**Addendum No. 4
October 27, 2023**

Project: **Harrisburg South Middle School Theatre Addition**
Harrisburg, South Dakota
Architecture Incorporated Project #3024

Sheet Contents **DEMOLITION FLOOR PLAN - AREA B**

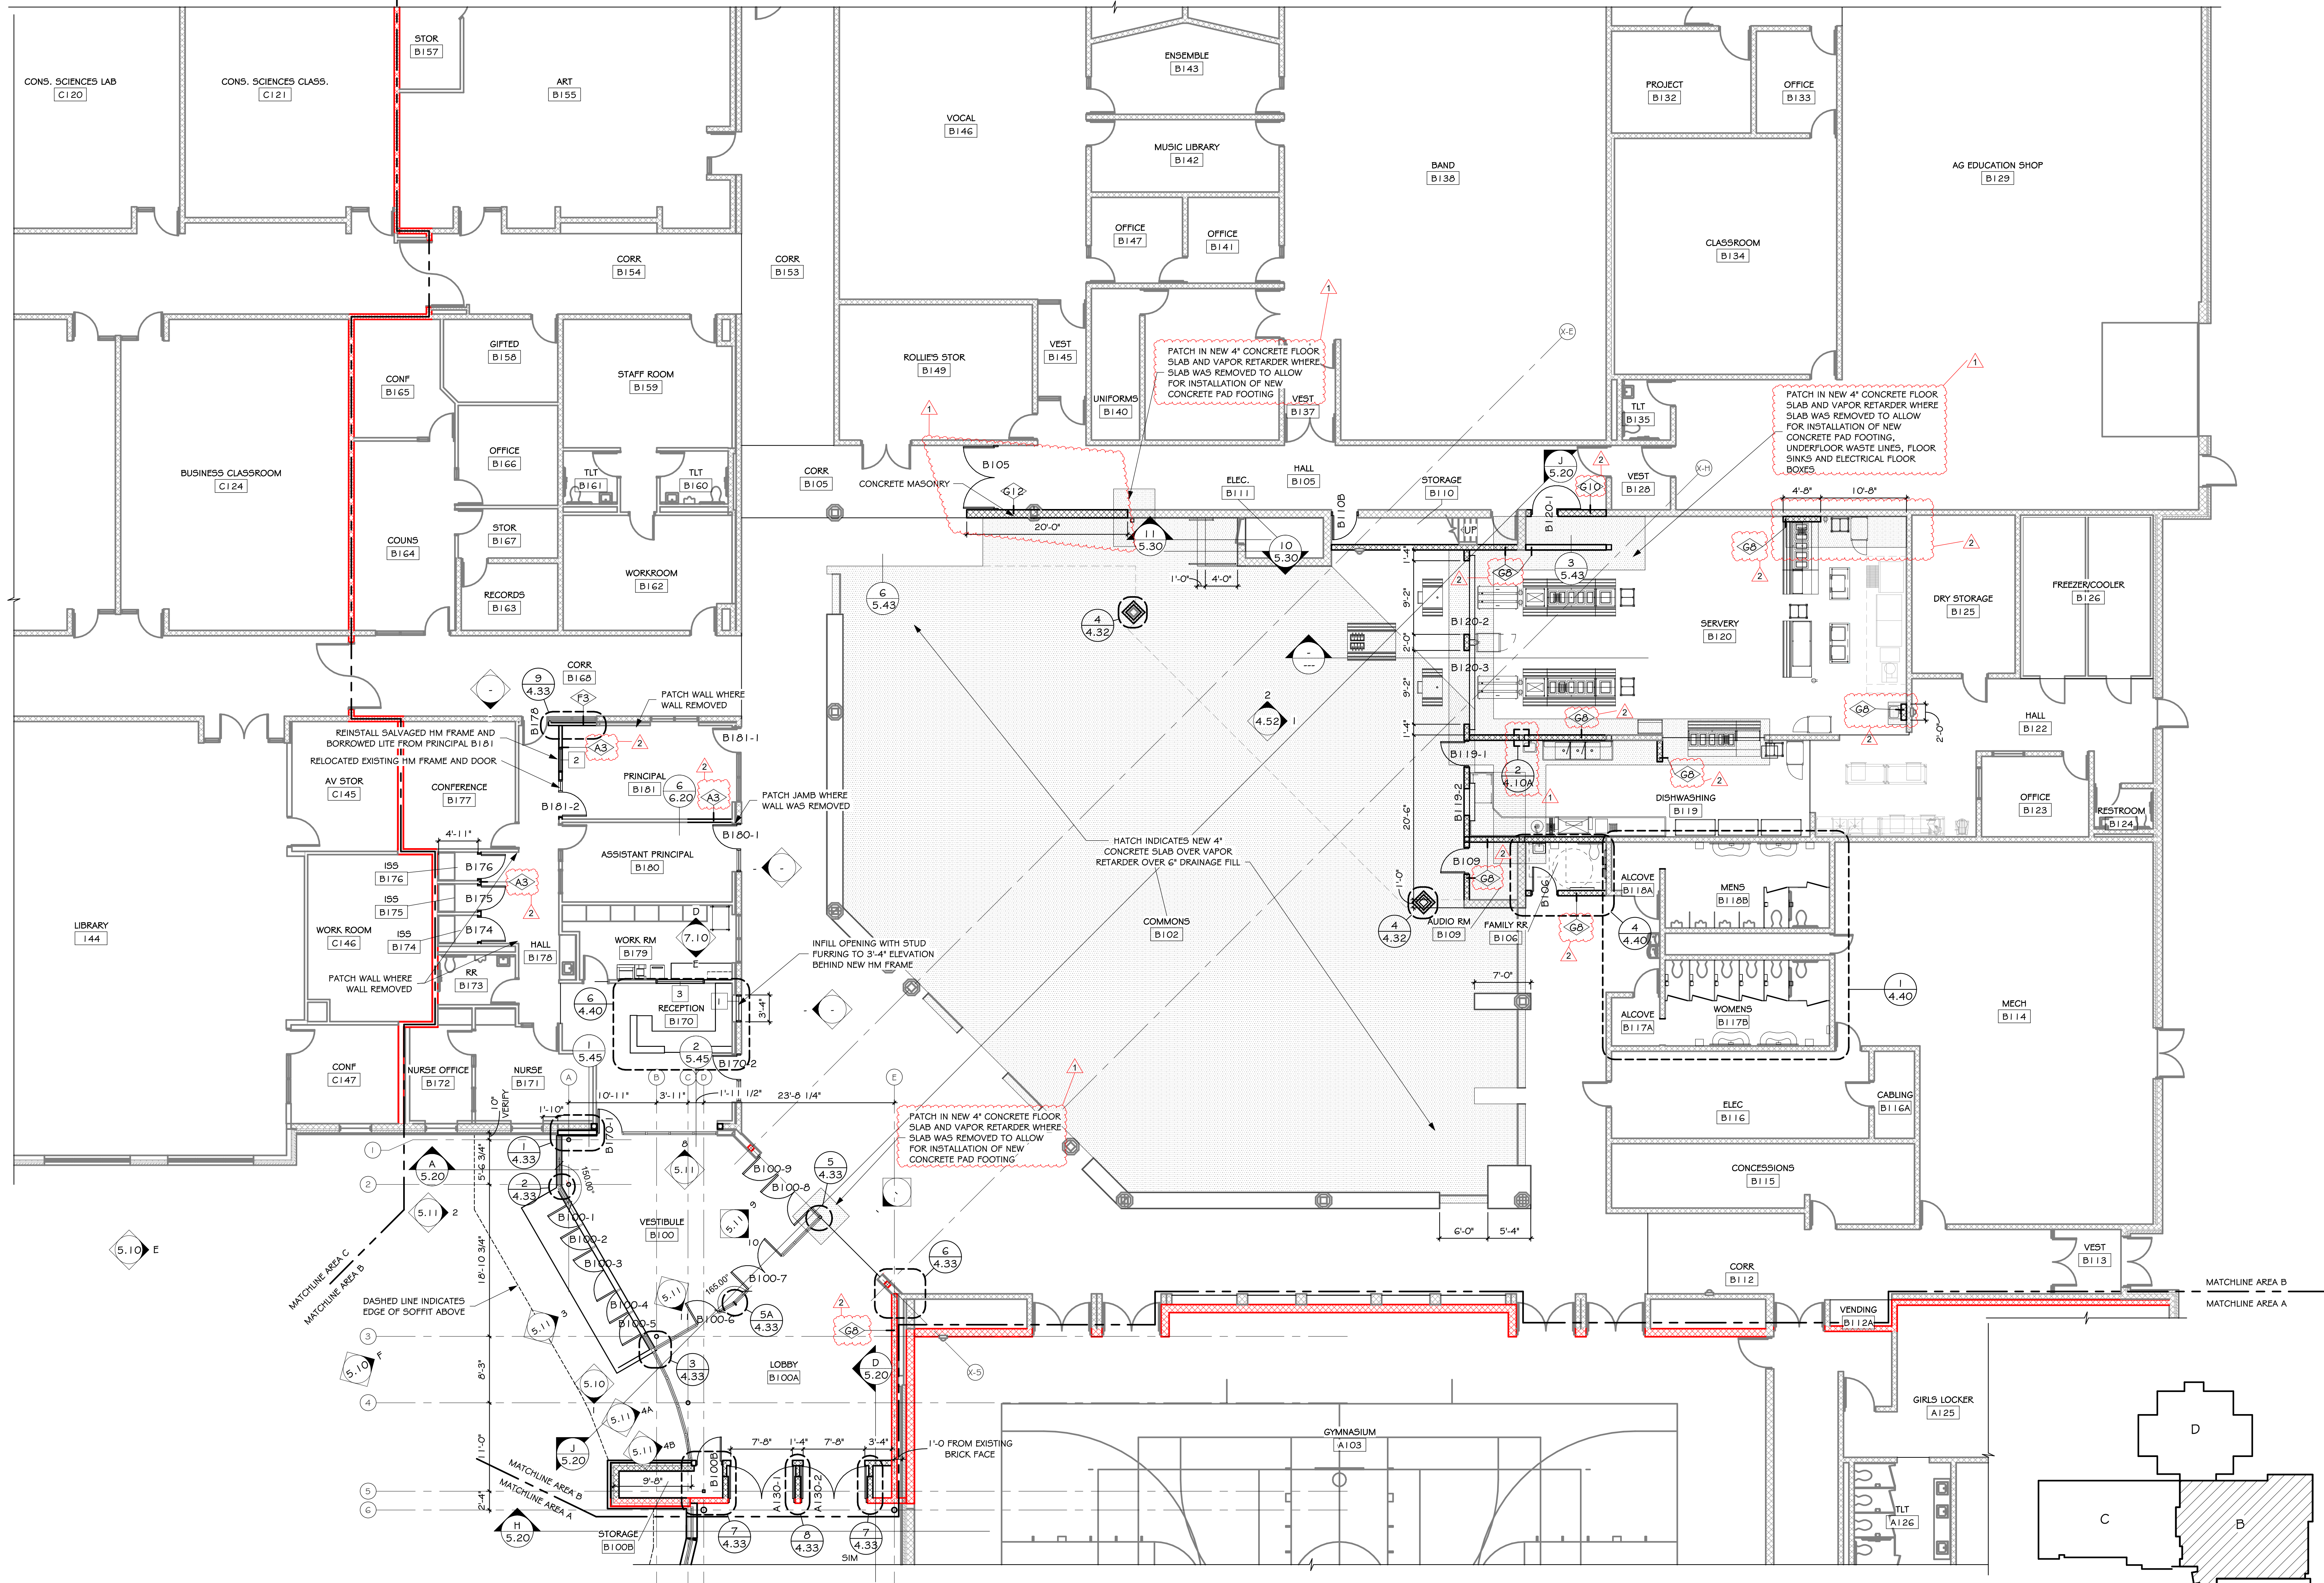
a) Reference revised sheet 4.00B, with revision date of 10-26-23, attached at the end of this addendum, for additional floor slab demo in Served B120.

9 HEAD
4.30 SCALE: 1 1/2" = 1'-0"

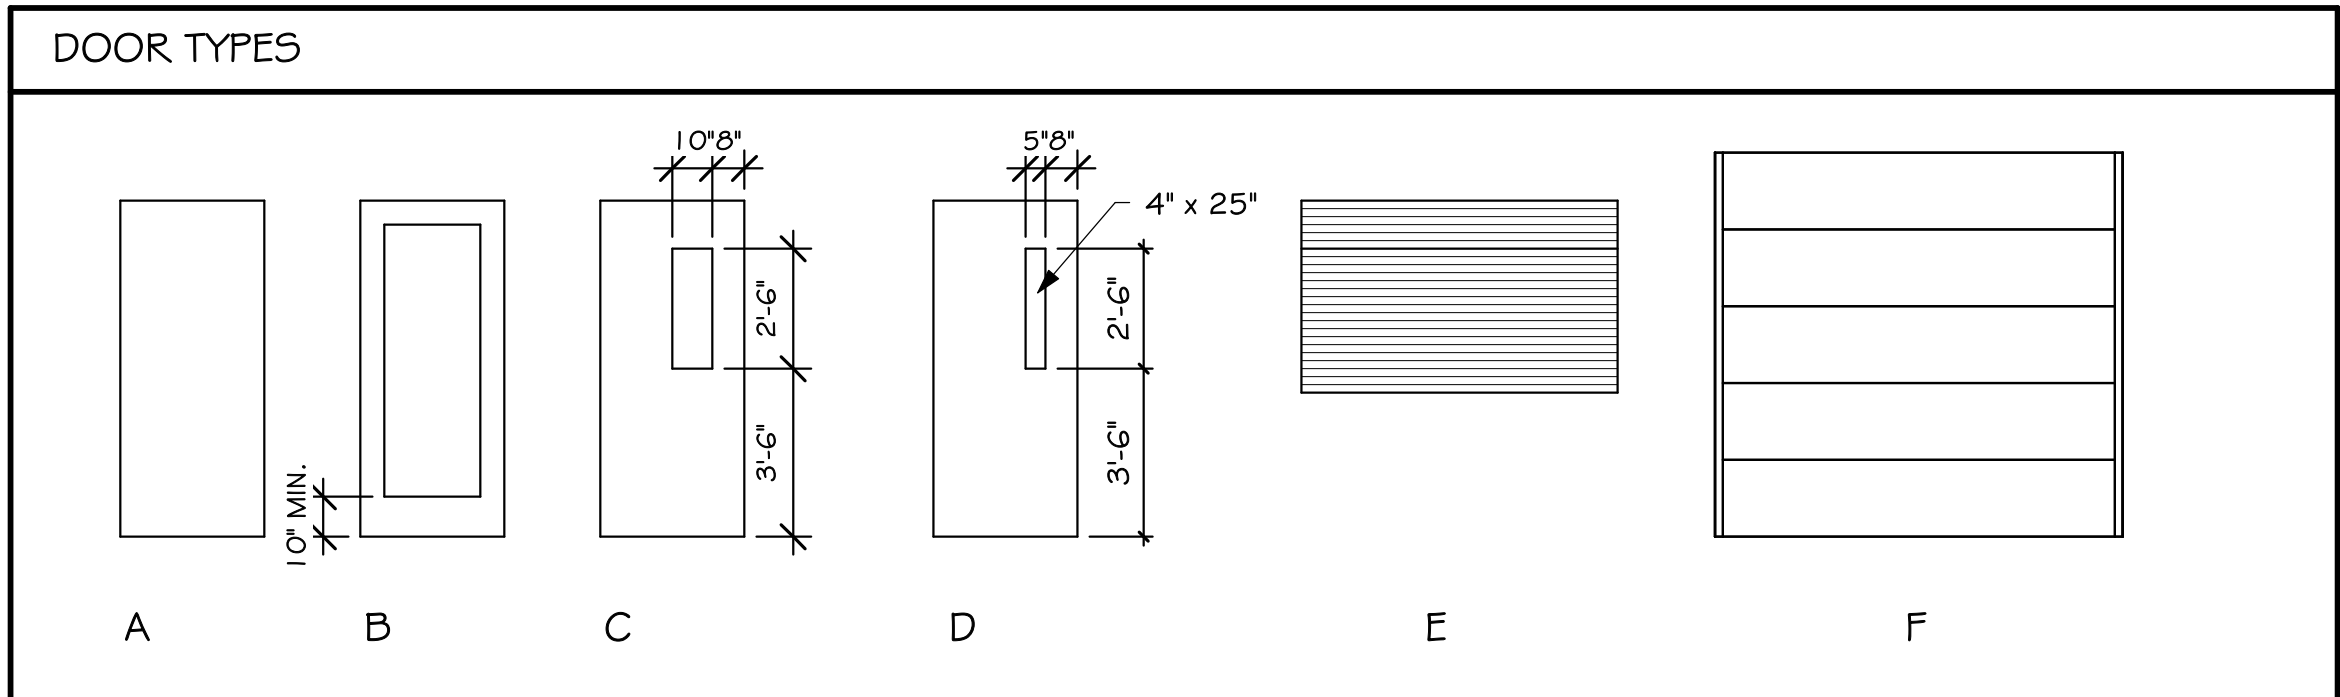
- xix) Reference *revised* drawing Sheet 4.30, with revision date of 10-26-23, attached to the end of this addendum for newly added details. **JAMB - 7/4.30, HEAD/SILL - 8/4.30, HEAD - 9/4.30, JAMB - 10/4.30, HEAD - 11/4.30, and JAMB - 12/4.30**

11 HEAD
4.30 SCALE: 1 1/2" = 1'-0"

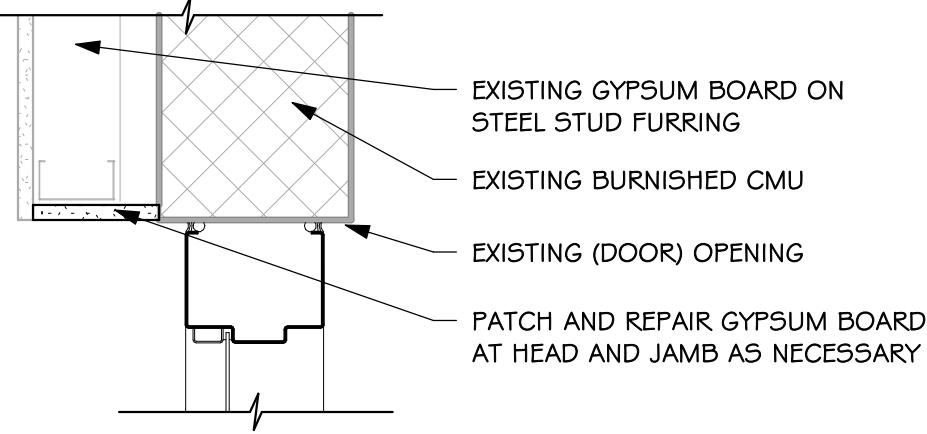
- xi) Door B120-1 – Change door glass from '~~1/4" CLEAR~~' to '**1/4" SAFETY**'.
 - xii) Door B120-2 – provide head detail **11/4.30** and jamb detail **12/4.30**.

- xiii) Door B120-3 – provide head detail **11/4.30** and jamb detail **12/4.30**.
 - xiv) Door B174 – change door glass from '~~1/4" CLEAR~~' to '**1/4" SFTY**'.
